Town of Medway  
**DESIGN REVIEW COMMITTEE**  
 155 Village Street, Medway MA 02053  
 (508) 533-3291

DRC Meeting Minutes: November 7th, 2016  
 Thayer House, Medway

**Medway Green Townhomes at 176 Main St:**

## **Medway Greens – 176 & 178 Main Street**

**SITE PLAN**  
 IN  
 MEDWAY, MASSACHUSETTS

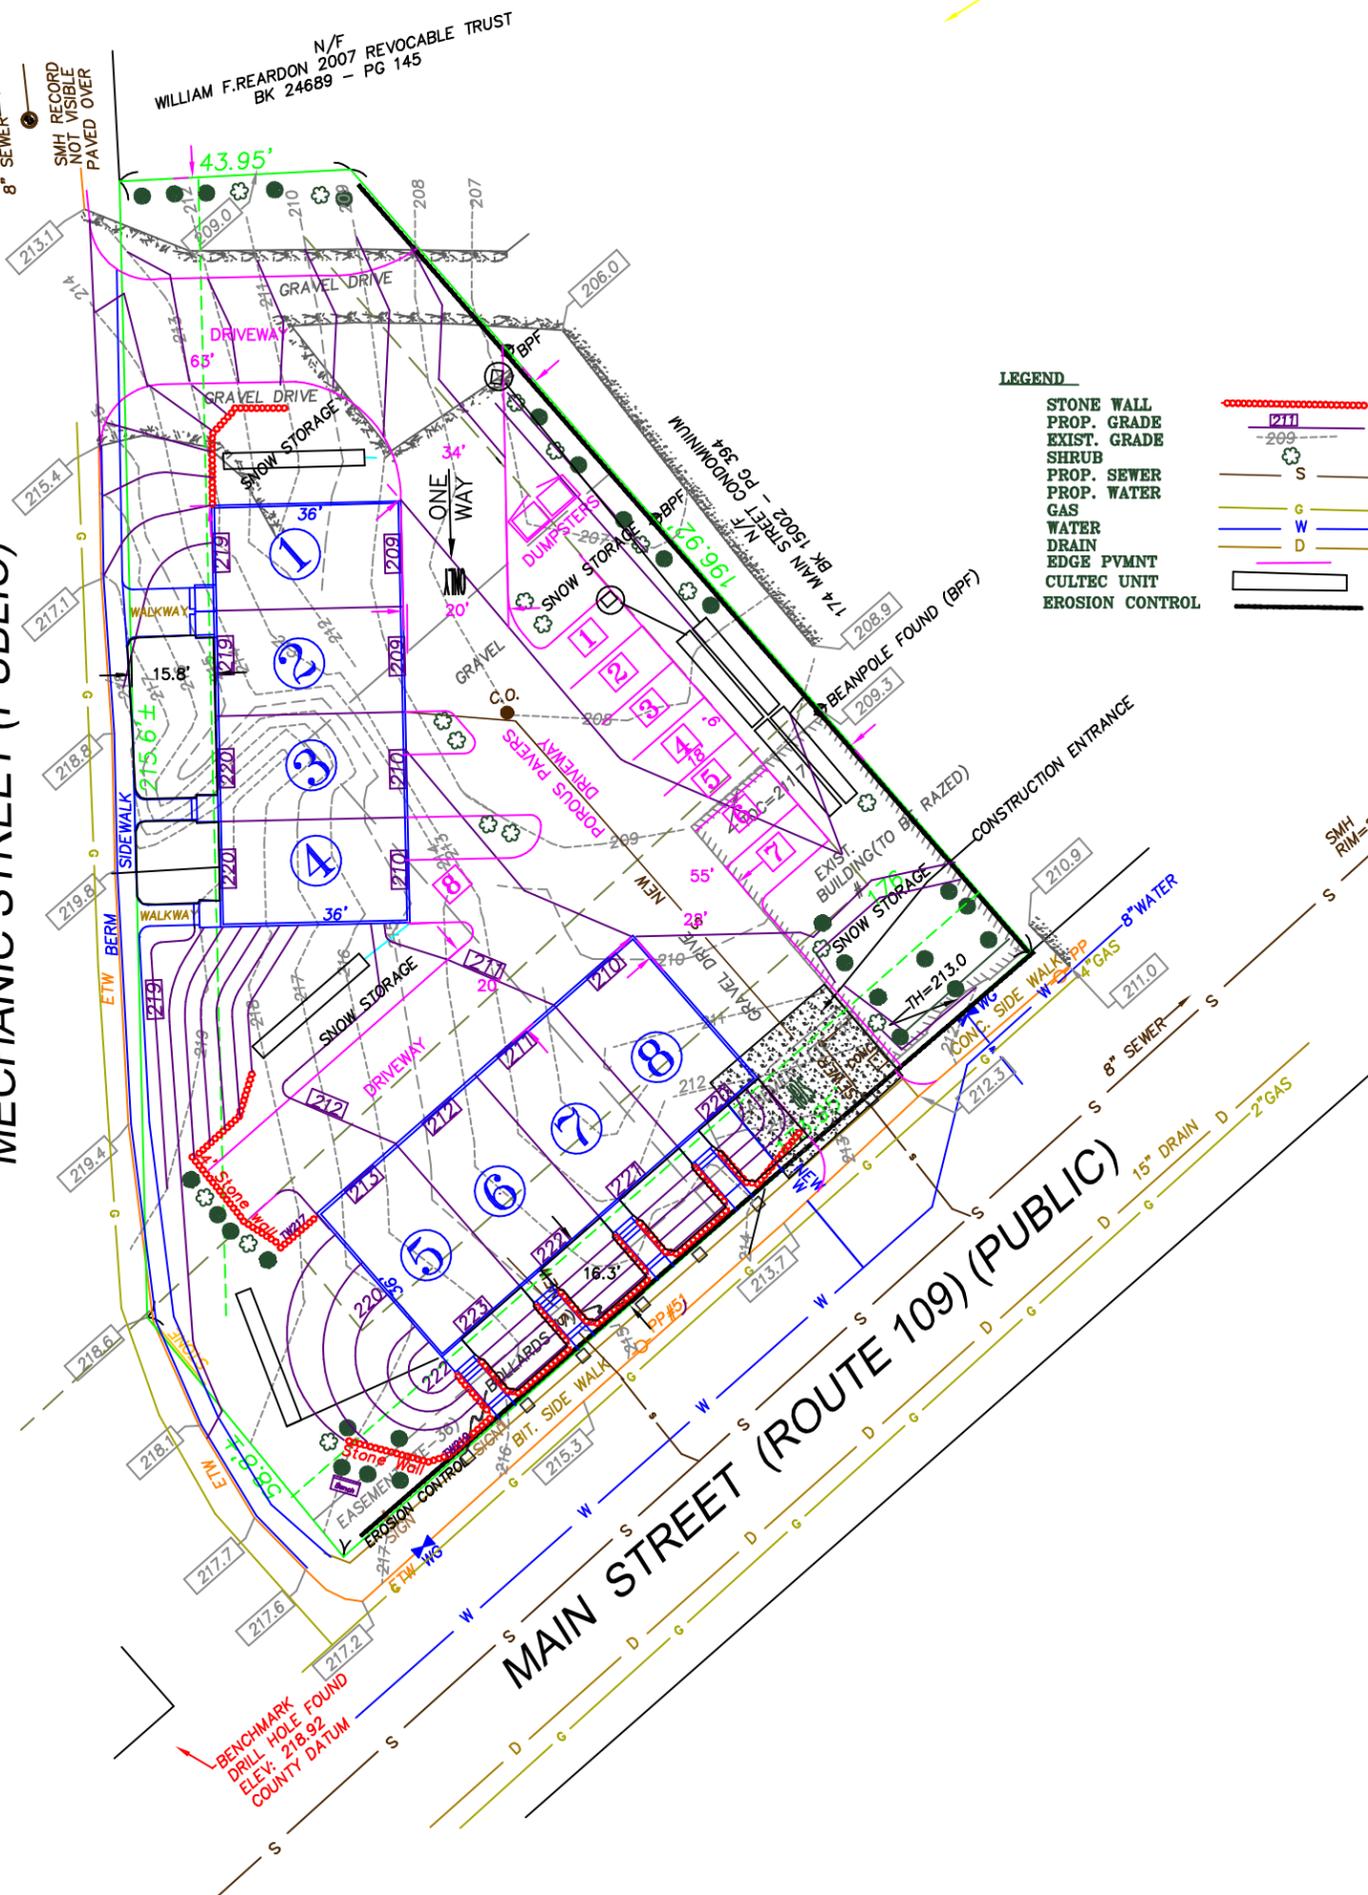
Recommendations on screening, lighting and landscaping concerns were discussed. The DRC recommended both a stockade fences and some type of evergreen bushes and trees as a buffer in between the street and townhouses. Lighting from adjacent buildings both now and in the future, were also considered.

Chairmen Buckley voiced his concern with the speed in which vehicles coming off the roads into driveway would be going. Mr. Tiberi explained the grade in elevation limited options where the driveway entrances could be placed but had discussed the possibility of a change in traffic pattern with the police. As discussed, the units would have two parking spots per unit which as Ms. Affleck-Childs pointed out exceeded the bi-law requirement of 1.5 per unit thus allowing the extra parking spots to be used in theory by visitors. Mechanic St while not zoned as a designated parking spot could offer limited parking as well as several other areas close by – on a limited basis.

- Sharon Gaffney to redraw site plan featuring units with 8-foot roof pitch, remove oval design on front door, rework “notches” in between units, incorporate air condensers and mail boxes once Post Office comments on what type of mail box is required.
- Ron/Sharon to provide two elevation renderings of proposed site: one from the front yard of house across the street featuring corners and face of each unit and one from the parking lot of West Medway Liquor Store (175 Main Street) looking onto the site from the east.
- When landscaping design is drawn – show it on a separate sheet
- Jessica/Committee to forward recommended color samples to Ron/Sharon.

ELEVATIONS II

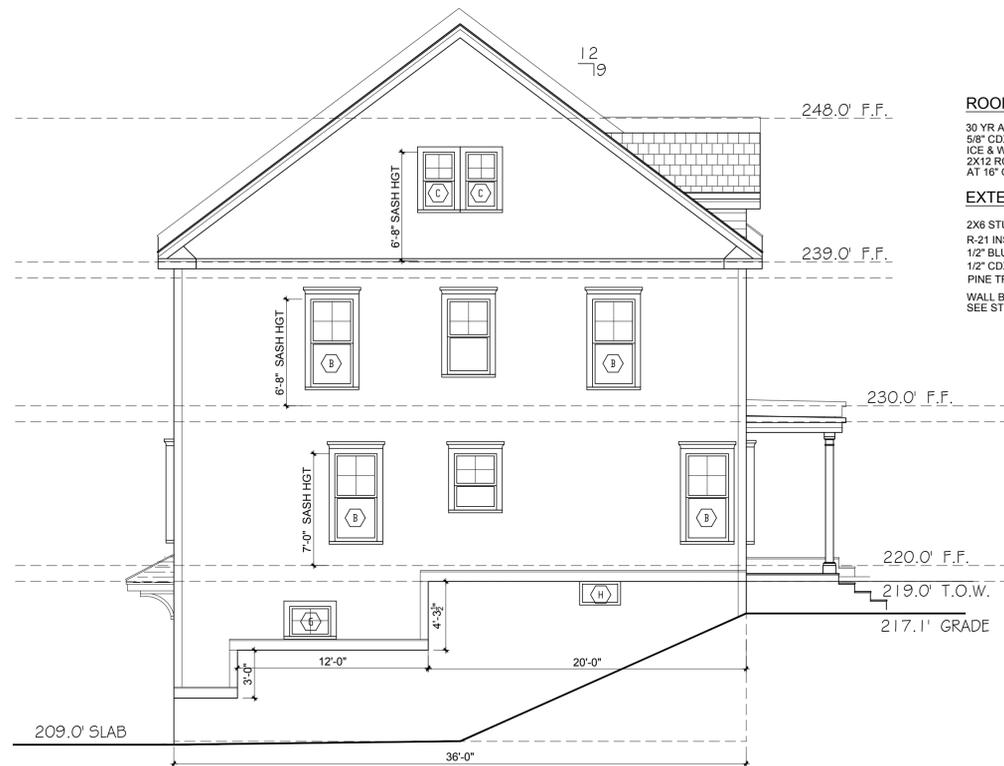
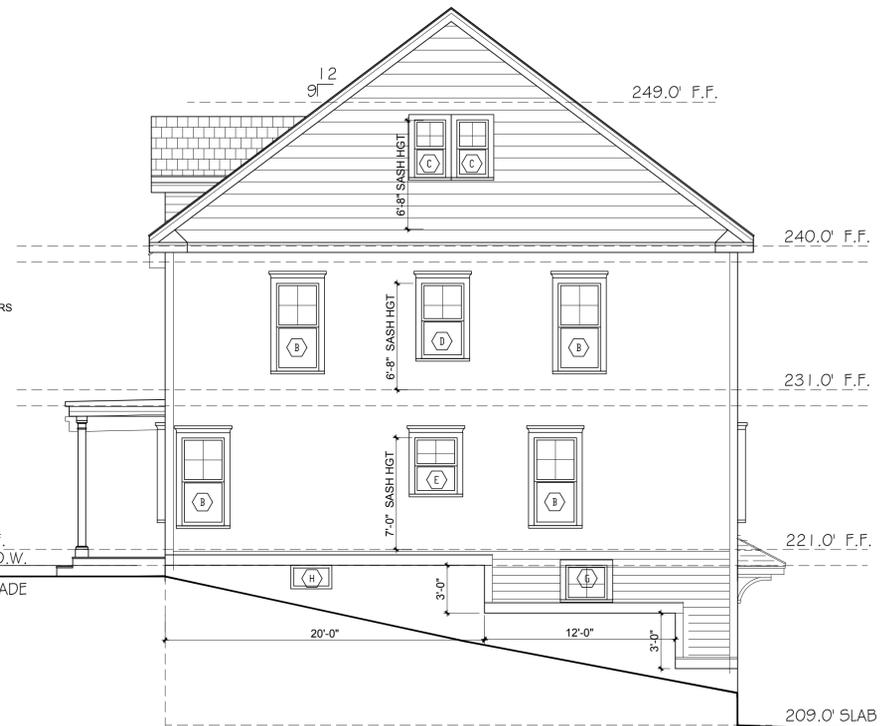
Units have a pull-down attic in hallway with attic offering additional storage. Pitch of roof was discussed by committee as being steep at a 9-foot+ pitch with building already tall. It was suggested to adjust the proportions drawn with an 8-foot pitch instead.

- Third floor windows **must have** an actual glass window in the same style.
- Downspouts could be added (row-houses in Charlestown offered as example)
- Adjust the amount of functional wall exposed on the north side wall on Mechanics St.
- Color of windows as black or bronze instead of white
- Fence **cannot be** chain link or white plastic but recommend a black wrought iron type (fence at Medway Commons as example)
- Enclosure around dumpster must fully screen dumpster from view.
- Chimney details not depicted on site plans. Could offer a more historic feel, break-up roof line and keep with Medway esthetic.
- Color combinations to consider against China Rose brick are light grays or blues and maybe some greens.
